NLS2001026
March 7, 2001

Subject: Core Operating Limits Report, Cycle 20, Revision 1
Cooper Nuclear Station
NRC Docket No. 50-298, DPR-46

COOPER NUCLEAR STATION

Cycle 20
Revision 1

Figure 1

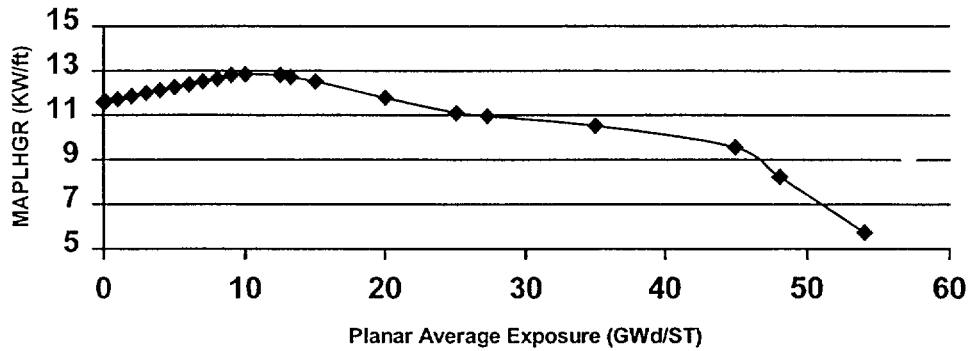
By letter dated April 18, 2000 (Reference), the Nebraska Public Power District (District) submitted the Core Operating Limits Report (COLR) for Cycle 20 operation at Cooper Nuclear Station. Since that submittal our fuel vendor has derived improved generic thermal-mechanical limits for the GE9B product line. The new generic thermal-mechanical limits for the GE9B fuel will provide additional operating margin for the GE9B fuel. The generic limits change some of the Maximum Average Planar Linear Heat Generation Rate (MAPLHGR) limits of the GE9B fuel shown in the Cycle 20 Core Operating Limits Report Revision 0 (Reference). The COLR is being revised to update the MAPLGHRs for the GE9B fuel to the new generic values.

DATA COORDINATES (Reference 14)
